Work Order ID 160360

Item ID: D350-607-541 Accept *N900040100* Setup Start *NS1*
 Revision ID: Stop *NS2*
 Item Name: AS350/AS355 Quick Release Heli-Utility-Basket™ Long, Heavy Duty Lid
 Start Date: 5/2/2017 Start Qty: 1.00 *1* Cust Item ID:
 Required Date: 5/12/2017 Req'd Qty: 1.00 *1* Customer:
 Reference: SCHEDULED/C

DART SERVICE INSTRUCTION

TO AMEND INSTALLATION INSTRUCTIONS D350-607-3 Rev.D,
INSTALLATION INSTRUCTIONS D350-607-4 Rev. C AND
INSTRUCTIONS FOR CONTINUED AIRWORTHINESS ICA-D350-607 REV. 6

FIGURE 1: INSTALLATION OF D4775-041 FWD STRUT

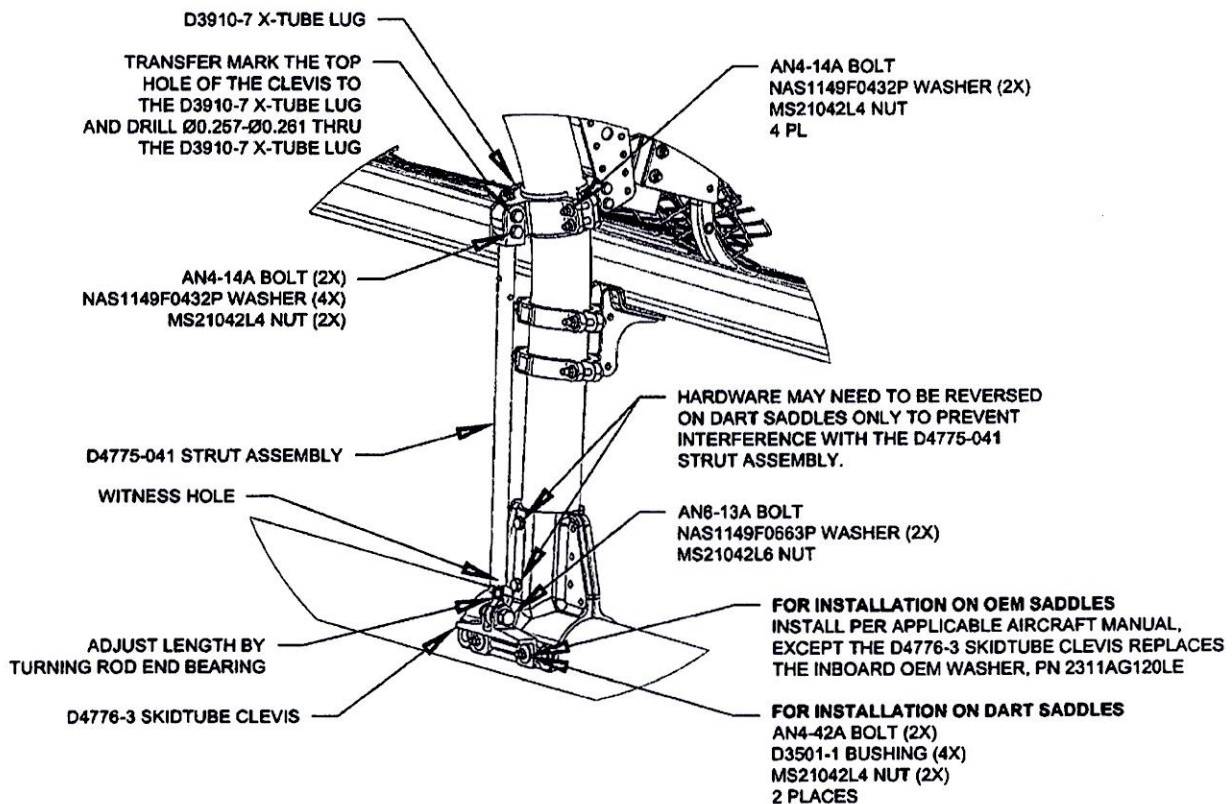
3.1 Substitute the Forward Lower D3910-5 X-Tube Lug with the D3910-7 X-Tube Lug as shown in Figure 1.

3.2 Install the forward D4775-041 Strut Assembly. Transfer mark from the upper hole on the clevis of the D4775-041 Strut Assembly to the D3910-7 X-tube Lug and drill thru the lug $\varnothing 0.257$ - $\varnothing 0.261$ as shown in Figure 1. Touch up chemical conversion coating per MIL-DTL-5541. Check the witness holes located at the bottom end of the D4775-041 Strut Assemblies to ensure that the thread from the rod end extends past the witness hole.
Torque MS21042L4/-4 nuts to 50-70 in-lbs (5.7-7.9 N-m). Torque MS21042L6/-6 nuts to 160-190 in-lbs (18.1-21.5 N-m).
